POWER PLANT - ENGINE - FANCASE - SUPPORT BRACKETS, ATTACHING BOLTS - VARIOUS CHANGES -
CATEGORY CODE 7 - MOD.ENG-71-0155

V2500-ENG-71-0155

REPLACE BOLTS - CLIPPING POINT SUPPORT BRACKET
FIG.1

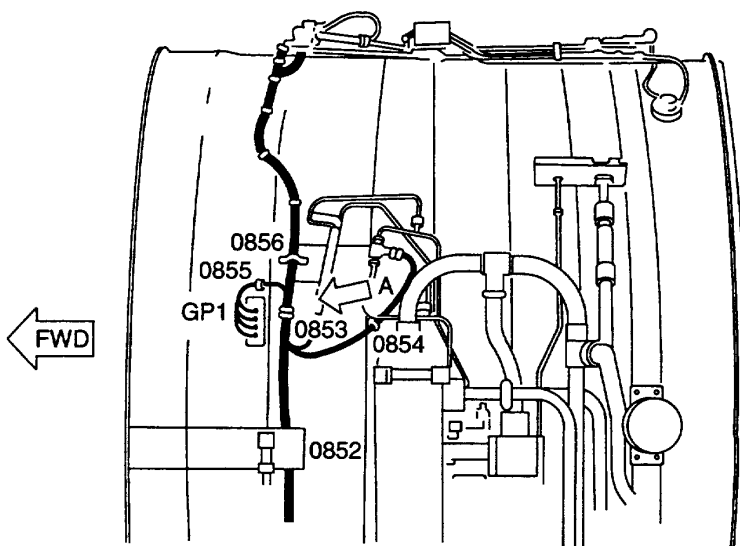
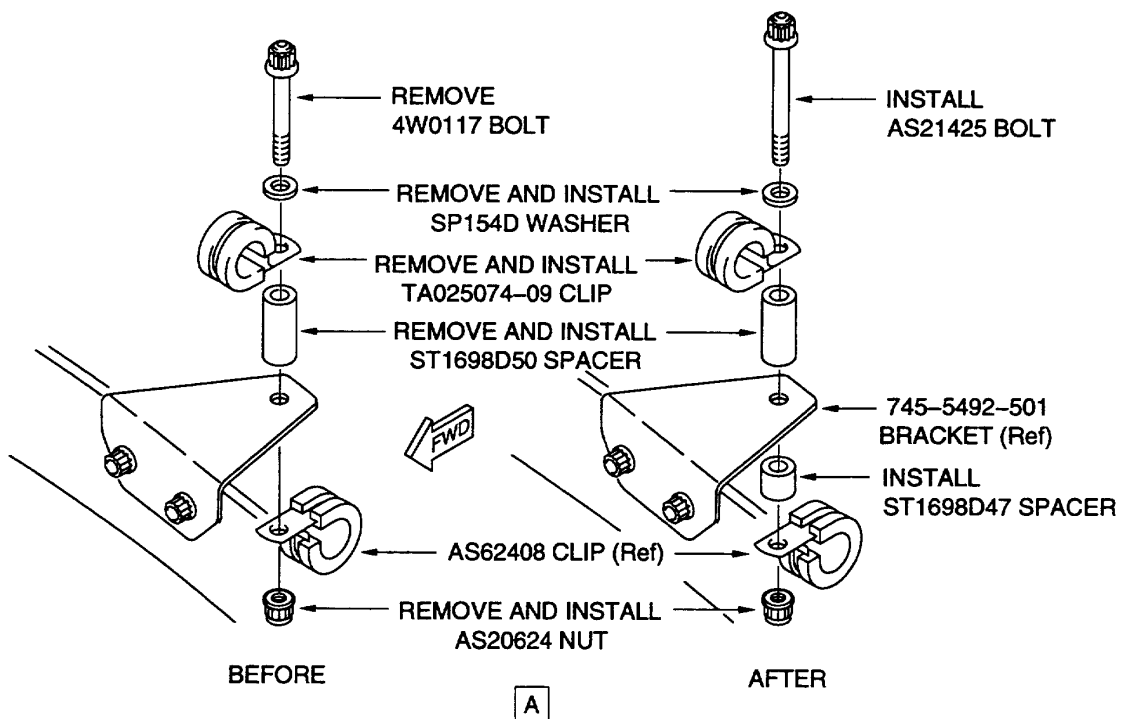
- (a) The existing bolts that attach the 740-5446-507 bracket are removed and replaced with longer bolts.
- (b) A new spacer is introduced at clipping point CP0853 and the existing bolt is replaced with a longer bolt.
- (c) The existing bolts that attach the 745-5425-501 bracket at clipping point CP0859 are replaced with longer bolts.
- (d) The existing bolt that attaches the 745-5425-50 bracket at clipping points CP0858 and CP1182 is replaced with a longer one.

- (1) Attach the 740-5446-507 Bracket to the Flange FC at clipping points CP0867 and CP0874 using two new 4W0165 Bolts and two 4W0002 Nuts as shown. Torque each nut to between 85 and 105 lb in (10 to 12 Nm). Refer to Figure 1.
- (2) Assemble clipping point CP0853 as shown with a new AS21425 Bolt, TA02507409 Clip, ST1698D50 Spacer, a new ST1698D47 Spacer, AS20624 Nut and SP154D Washer. Torque the bolt to between 36 and 45 lb in (4 to 5 Nm). Refer to Figure 2.
- (3) Attach the 745-5425-501 Bracket to the Flange FA1 at clipping point CP0859 using two new 4W0165 Bolts and two 4W0002 Nuts as shown. Torque each nut to between 85 and 105 lb in (10 to 12 Nm). Refer to Figure 3 Sht 1.
- (4) Install a new 4W0165 Bolt and a 4W0002 Nut at clipping points CP0858 and CP1182 as shown. Torque the nut to between 85 and 105 lb in (10 to 12 Nm). Refer to Figure 3 Sht 2.
